SUBJECT: NuScale Power, LLC Supplemental Response to NRC Request for Additional Information No. 164 (eRAI No. 8935) on the NuScale Design Certification Application

NuScale Supplemental Response to NRC Request for Additional Information eRAI No. 8935

NRC Question No.: 03.07.02-24

Figure 3.7.1-3: NuScale Horizontal CSDRS-HF at 5 Percent Damping

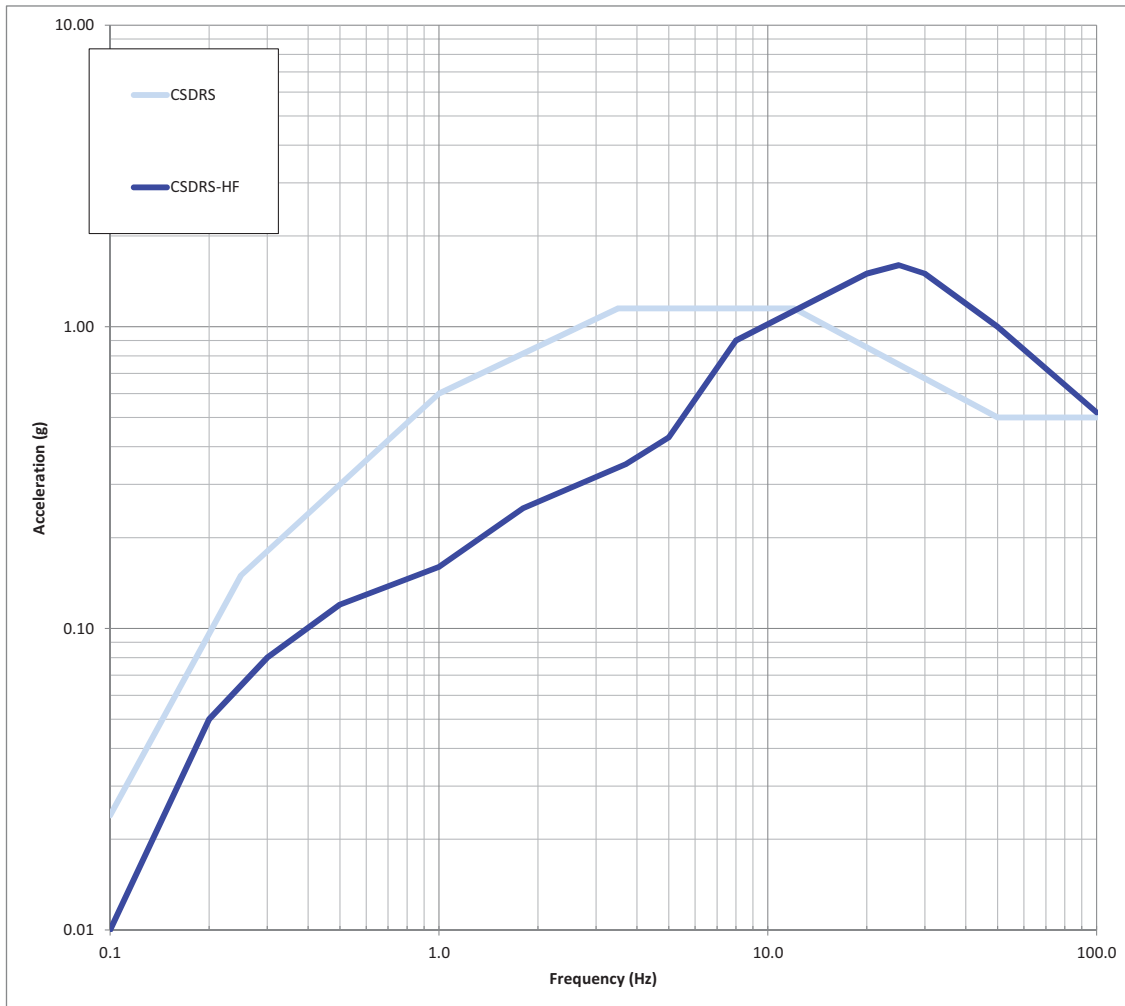
Notes have been added to FSAR Tier 1, Figures 5.0-3 and 5.0-4, and Tier 2 Figures 3.7.1-3 and

3.7.1-4 to clarify the basis of the “design basis seismic loads” for applicable SSCs.

Note: CSDRS-HF is evaluated for the RXB and CRB only

Figure 3.7.1-4: NuScale Vertical CSDRS-HF at 5 Percent Damping

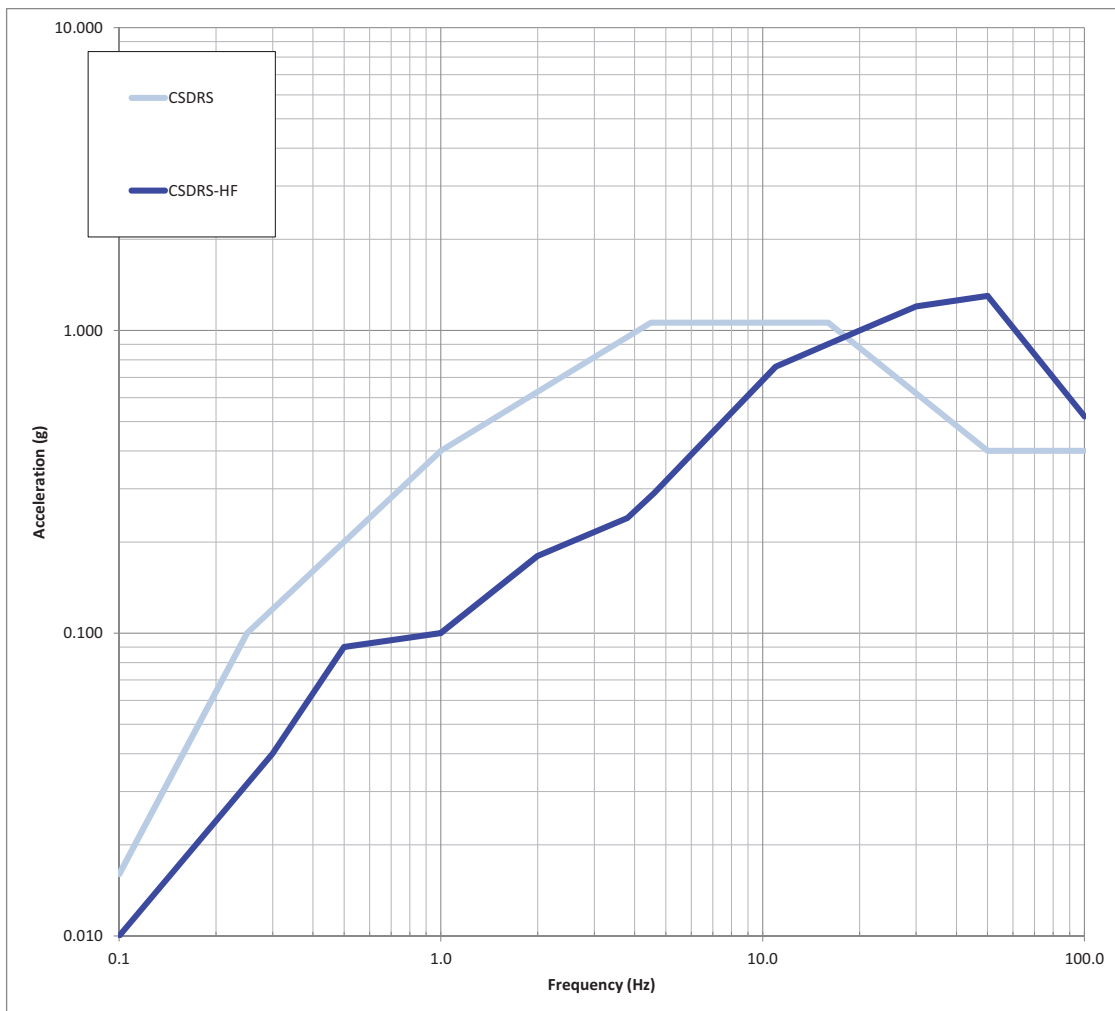
Note: CSDRS-HF is evaluated for the RXB and CRB only
